*Split Solitary Island—Amendments to charts with regard to reef north-westward of.*

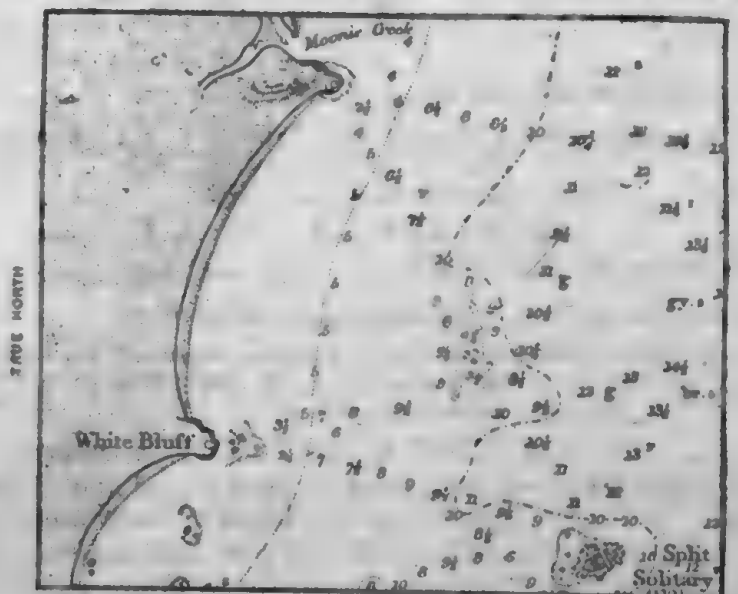
*Details*.—Amendments to the charts with regard to the reef north-westward of Split Solitary island, consequent upon a recent examination of the vicinity, are shown on the accompanying reproduction of a portion of chart No. 1026.

*Split Solitary Island—Amendments to charts with regard to reef north-westward of.*

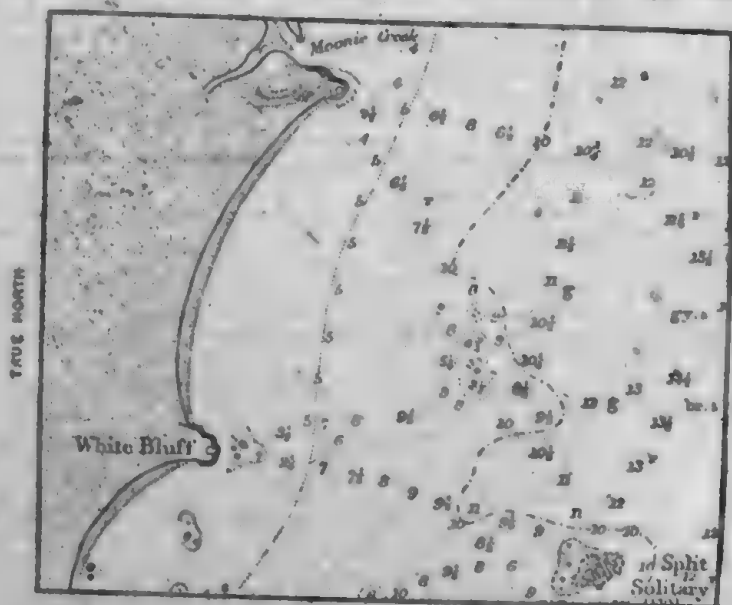
*Details.*—Amendments to the charts with regard to the reef north-westward of Split Solitary island, consequent upon a recent examination of the vicinity, are shown on the accompanying reproduction of a portion of chart No. 1026.

*Charts affected.*—No. 3401, Halsey harbour.

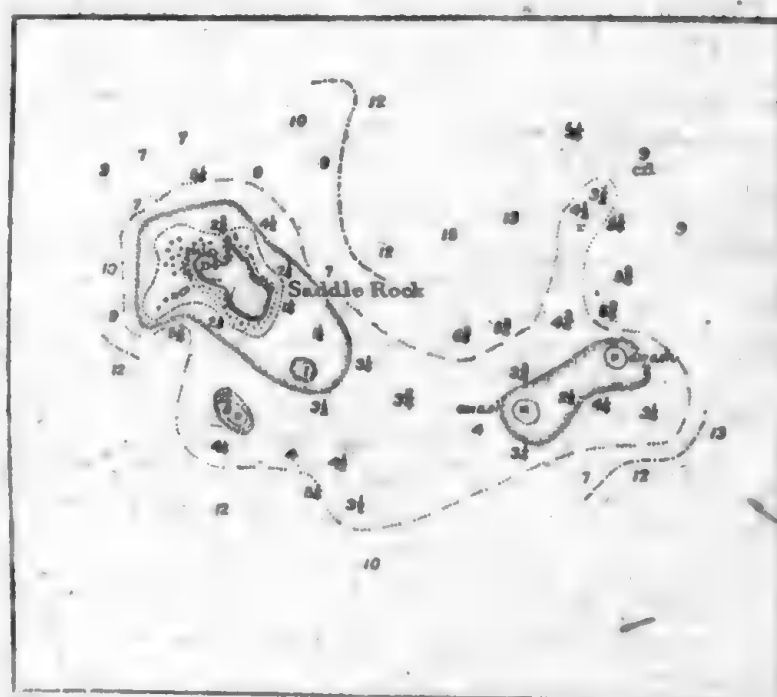
*Details.*—The accompanying reproduction of a portion of chart No. 3401 shows the necessary corrections to that chart with regard to the shoal eastward of Saddle rock.

*Split Solitary Island—Amendments to charts with regard to reef north-westward of.*

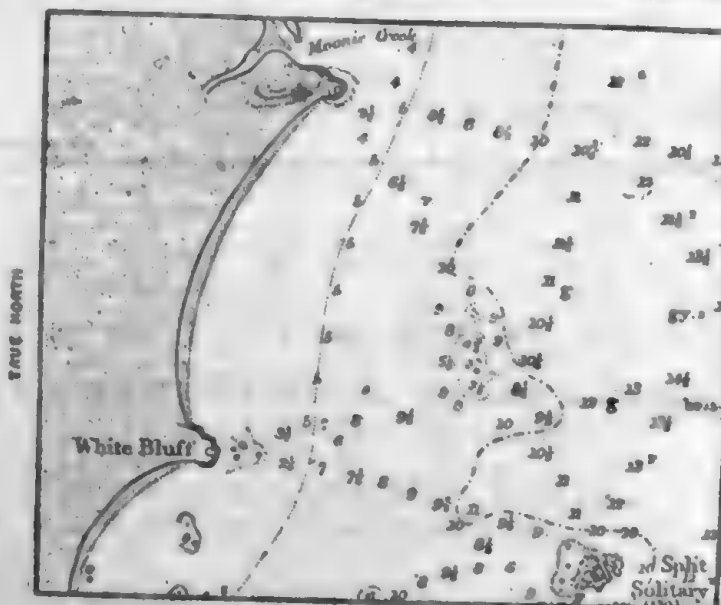
*Details.*—Amendments to the charts with regard to the reef north-westward of Split Solitary island, consequent upon a recent examination of the vicinity, are shown on the accompanying reproduction of a portion of chart No. 1026.

*Charts affected.*—No. 3401, Halsey harbour.

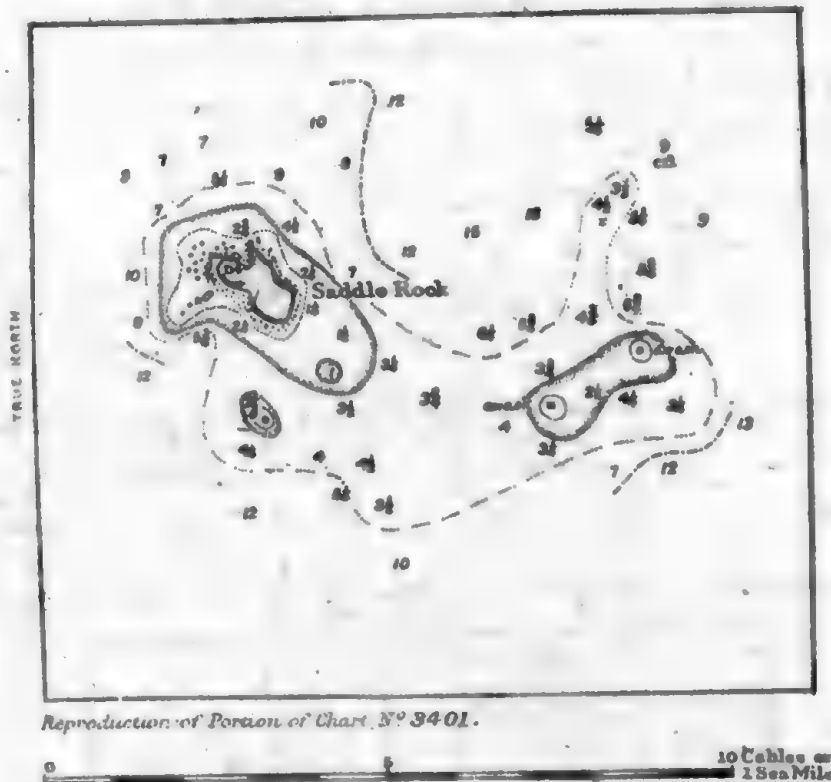
*Details.*—The accompanying reproduction of a portion of chart No. 3401 shows the necessary corrections to that chart with regard to the shoal eastward of Saddle rock.

Reproduction of Portion of Chart No. 2875.

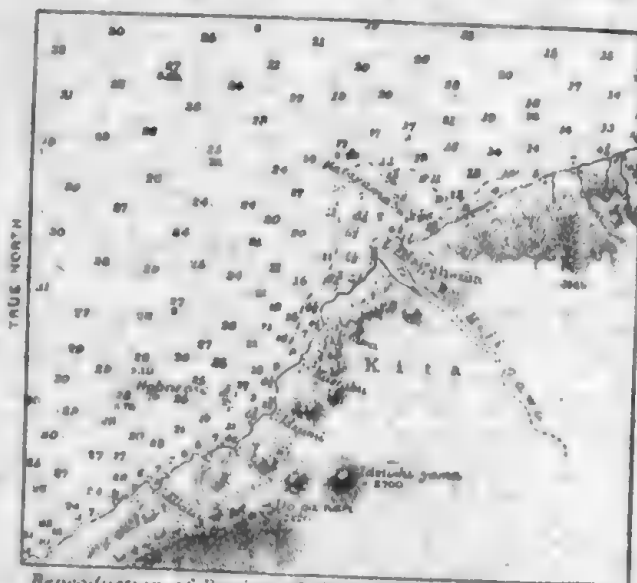
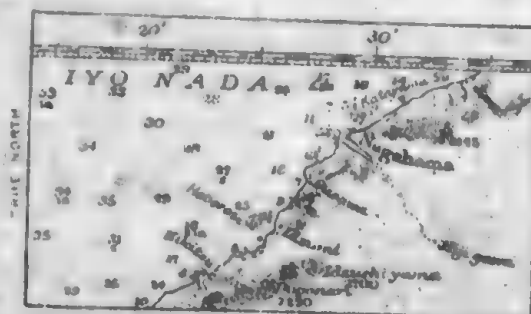
*Details.*—The accompanying reproduction of portions of charts Nos. 2875 and 1648 shows the necessary corrections to those charts with regard to depths, shoals and the coast line in the vicinity of Nagahama and approach.

*Reproduction of Portion of Chart N°934*

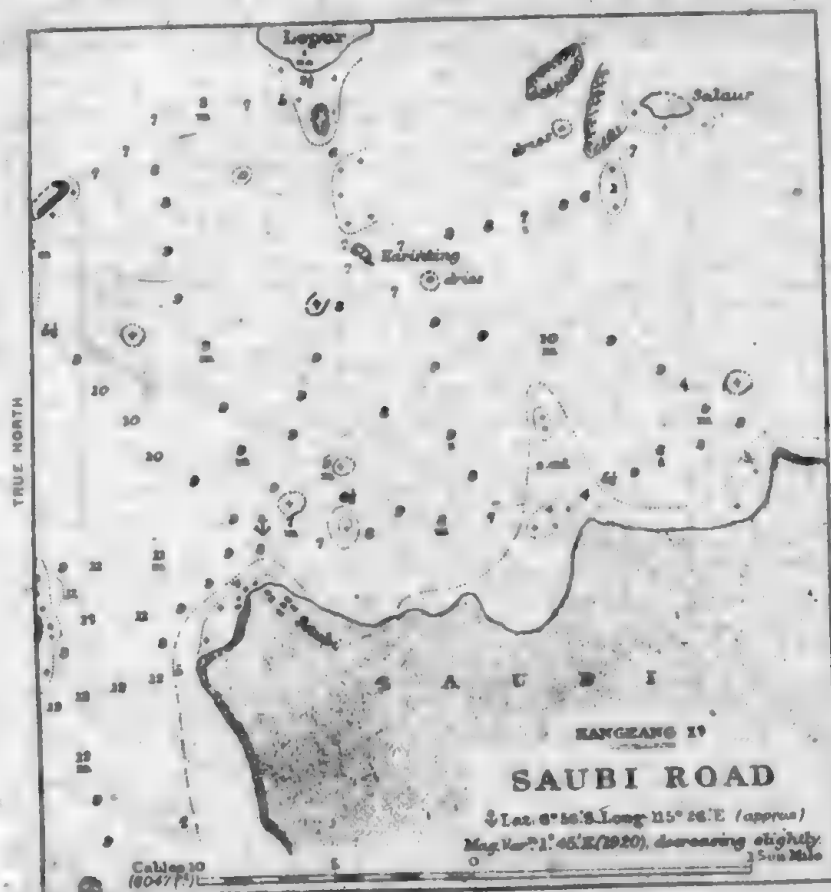
*Details.*—The accompanying reproduction of portions of charts Nos. 934 and 1654 shows the necessary corrections to those charts with regard to—

Reproduction of Portion of Chart No. 1070.

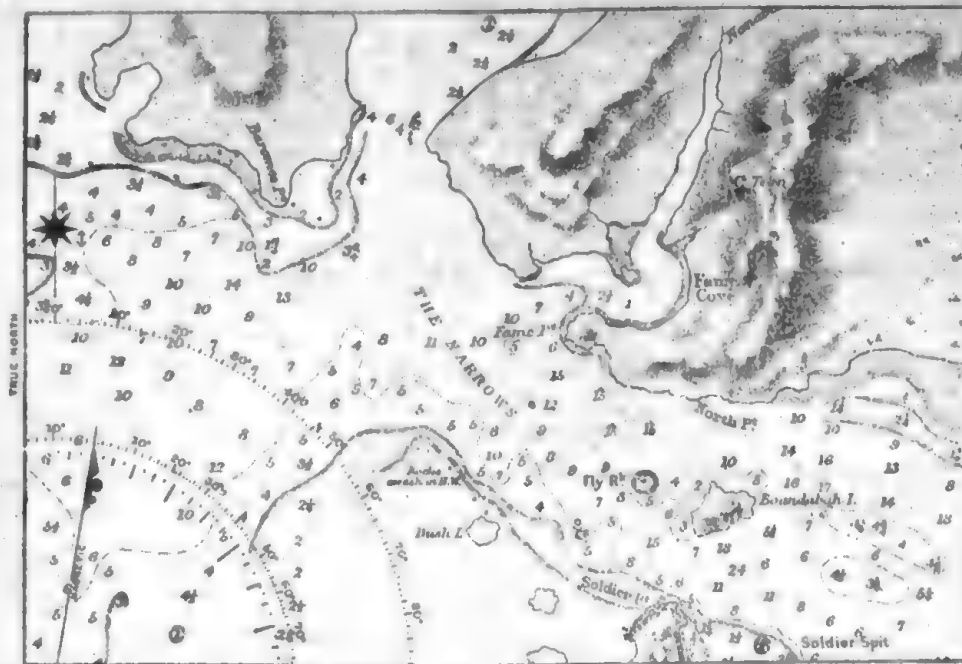
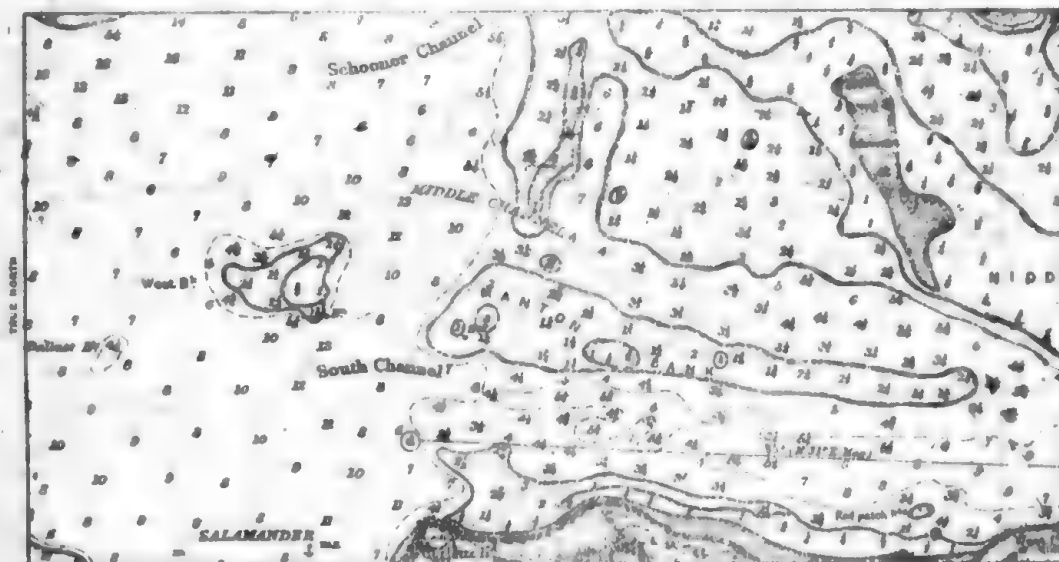
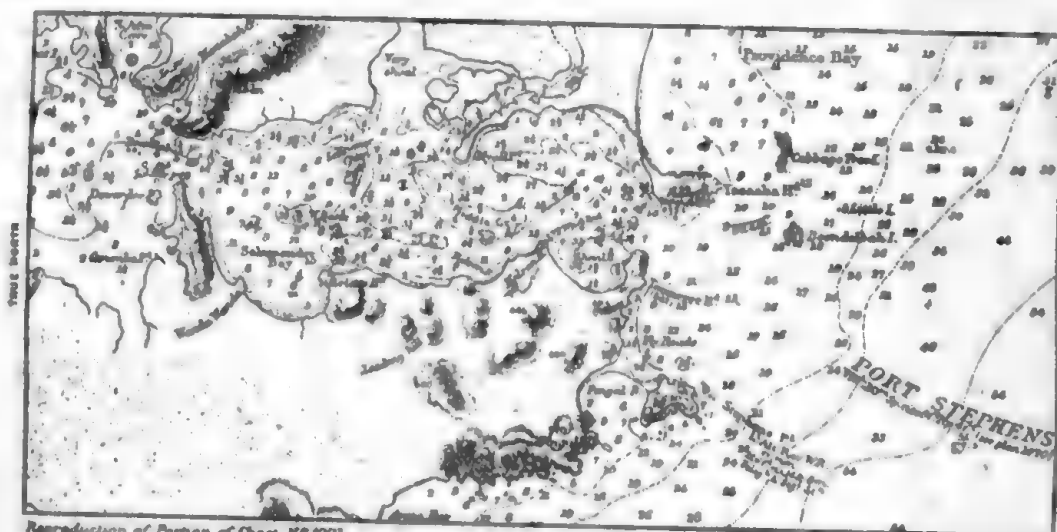
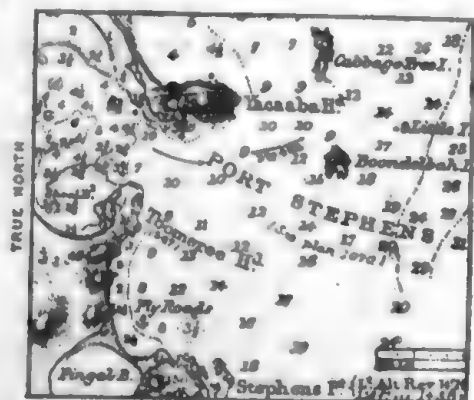
*Details.*—The accompanying reproductions of portions of charts Nos. 1070, 1021, 1024 and 3622 show the necessary corrections to those charts with regard to shoals, as revealed by a recent survey.

*Chart affected.*—No. 1999, Ports Lyttelton and Levy, and Pigeon bay, with plan.

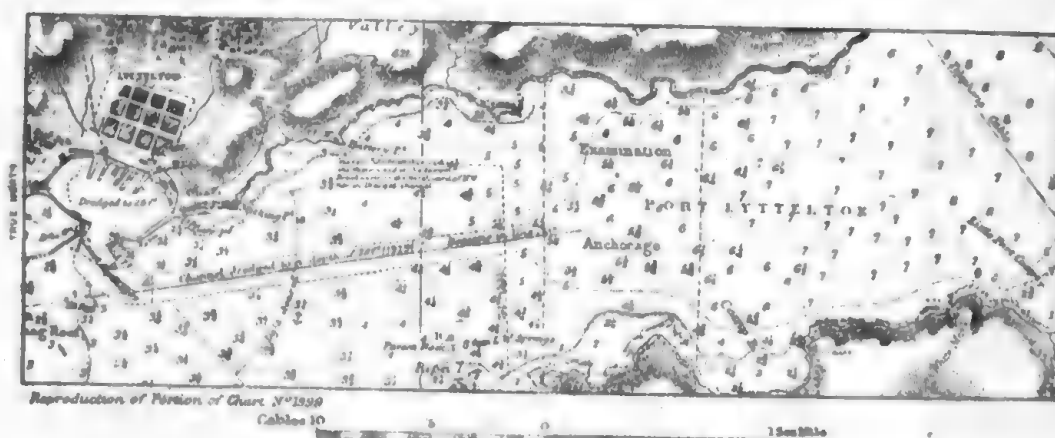
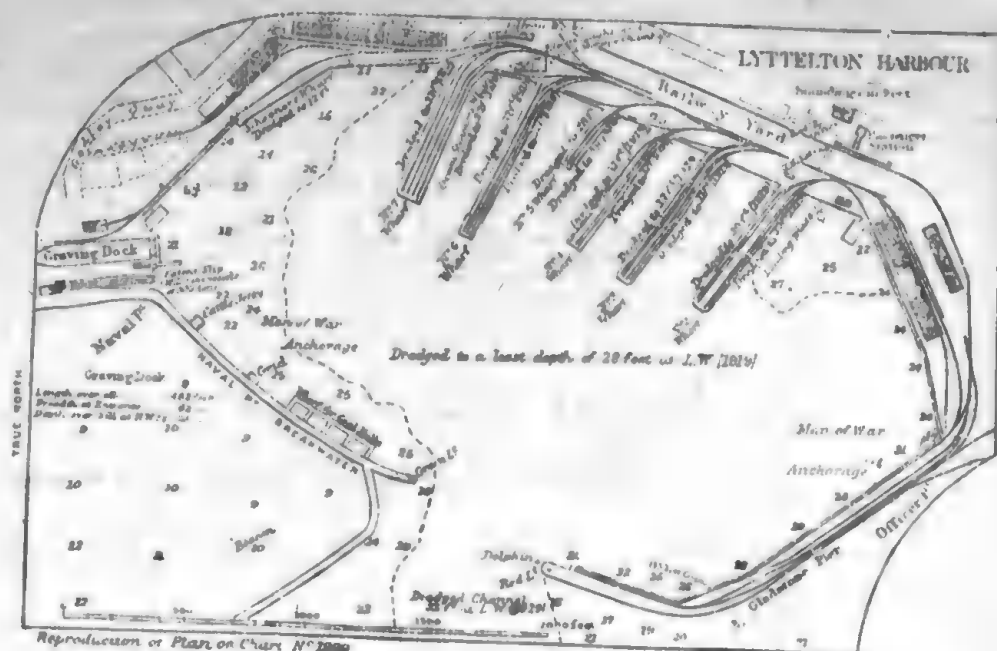
*Details.*—The accompanying reproductions of portions of chart No. 1999, show the necessary corrections to that chart with regard to the depths in Lyttelton harbour and the entrance channel.

*Charts affected.*—No. 2747, Entrance to Port Phillip.

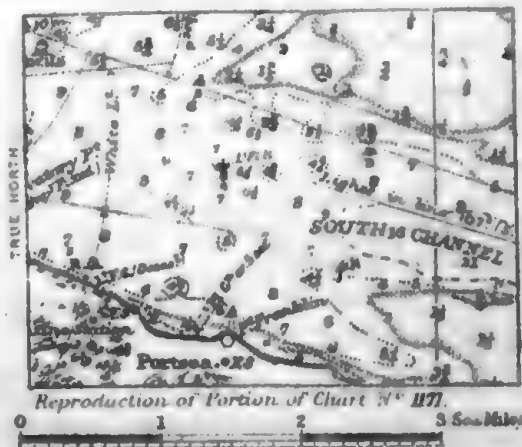
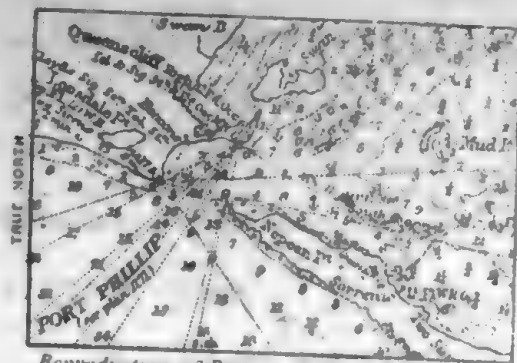
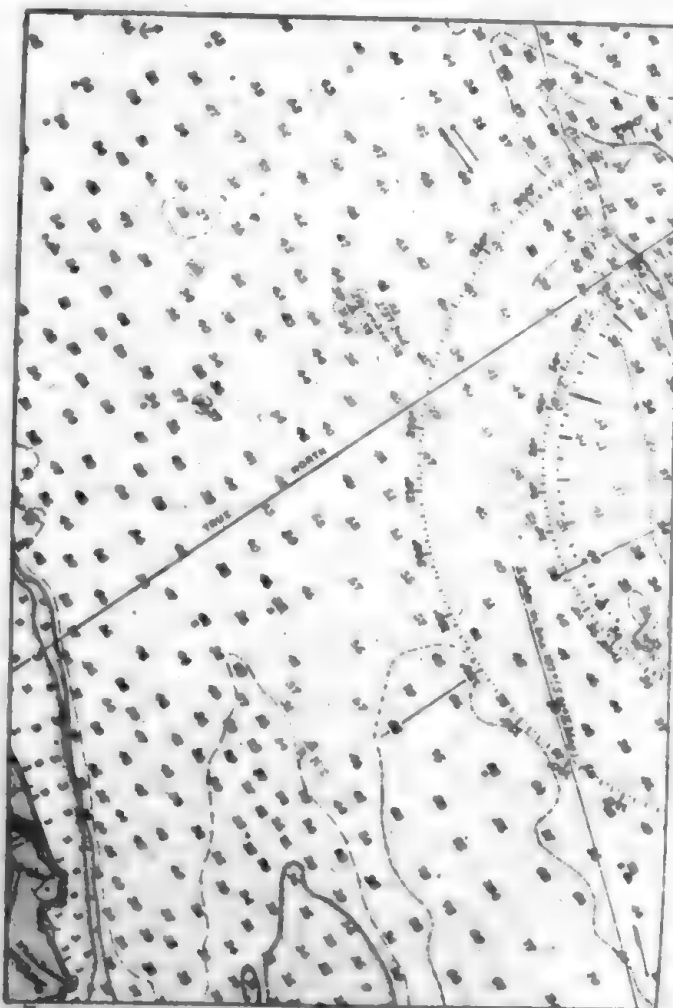
*Details.*—The accompanying reproductions of portions of charts Nos. 2747, 1171 and 1695b show the necessary correction to those charts with regard to alterations in depths in the South channel northward of Portsea.

From the reproductions it will also be seen that the positions of the light-buoy, Nos. 1, 2 and 3 buoys, and the buoy eastward of Portsea jetty have been slightly amended.

*Charts affected.*—No. 3720, Pontianak to Tanjong Bayung.

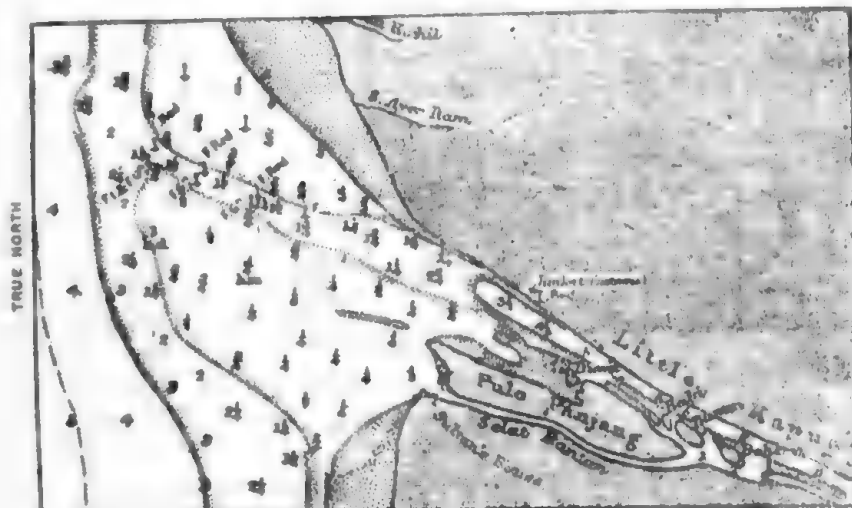
*Details.*—The accompanying reproduction of portions of charts Nos. 3720 and 3721 shows the necessary corrections to those charts with regard to depths, &c., in the entrance to Little Kapuas river, together with the amended position of the fixed red light at Junkat.

Reproduction of Portions of plan on Chart No. 684.

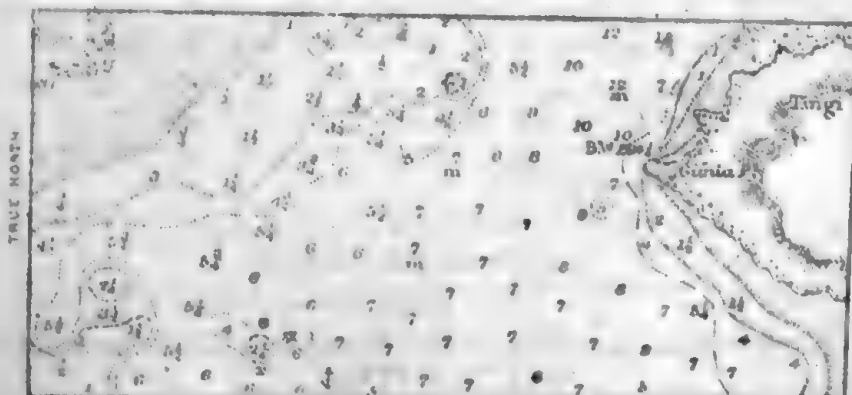
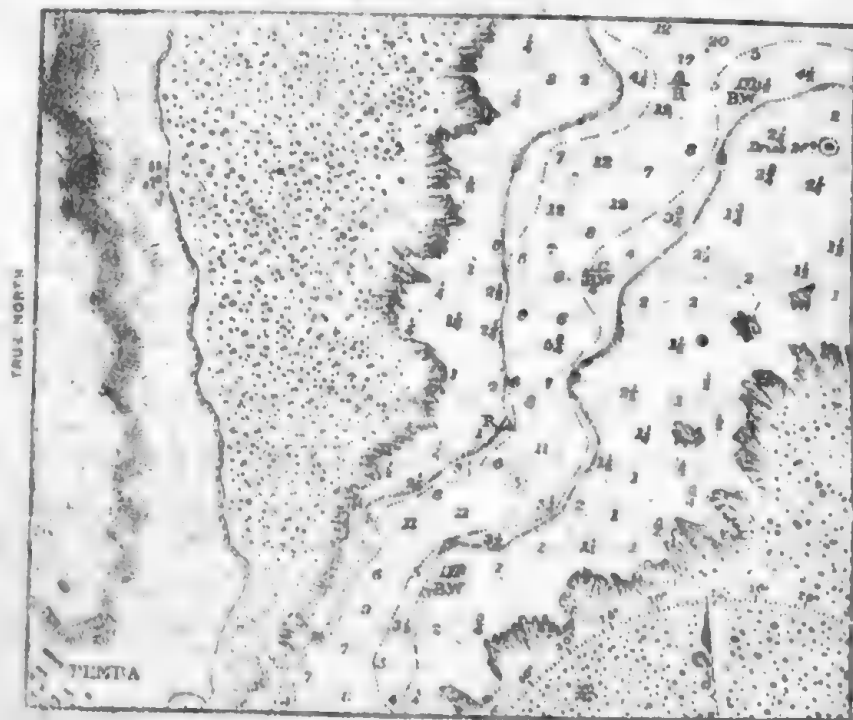
*Details.*—The accompanying reproduction of two portions of the plan of Mikindani harbour entrance on chart No. 684 shows the necessary corrections to that plan with regard to buoyage.
